RFI 134

Project: COOLEY LABORATORY RENOVATION
Job: 3146 COOLEY LAB, PPA# 10-0023
Customer: STOFMT MSU BOZEMAN
Issued To: CONSTRUCTION MANAGEMENT SERV.
P.O. BOX 7274
BOZEMAN, MT 59715

Item: NIXALITE BIRD CONTROL
Reference: Spec. Section 10290
Attachments: A4.3 Detail 2

2 ELEVATION WEST
SCALE: 1/8"=1'-0"

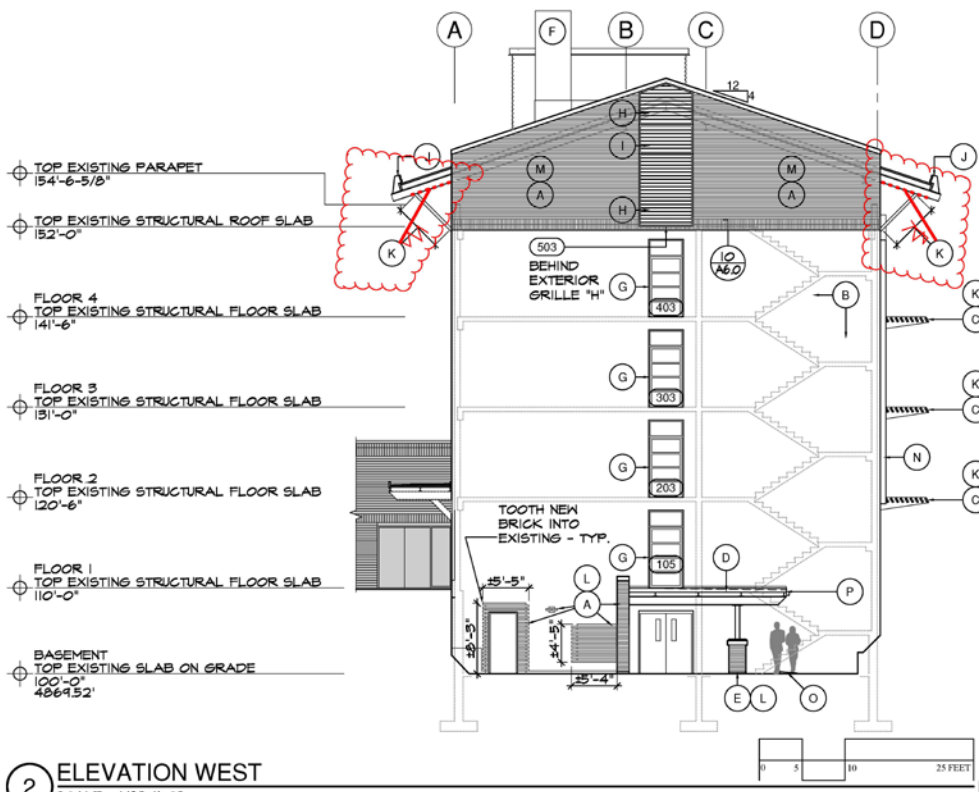
QUESTION:
There has been discussion regarding the placement of the nixalite at the roof knee braces. Because of the slope of the tube steel it does not appear to be a location for any birds to roost or nest. Would the Owner prefer to have the nixalite scheduled to be placed on the knee braces to be placed on the bottom flange of the rafter beams located above the knee braces?

Yes – Place the Nixalite on each side of the bottom flange of the rafter beams.

See Attached A4.3
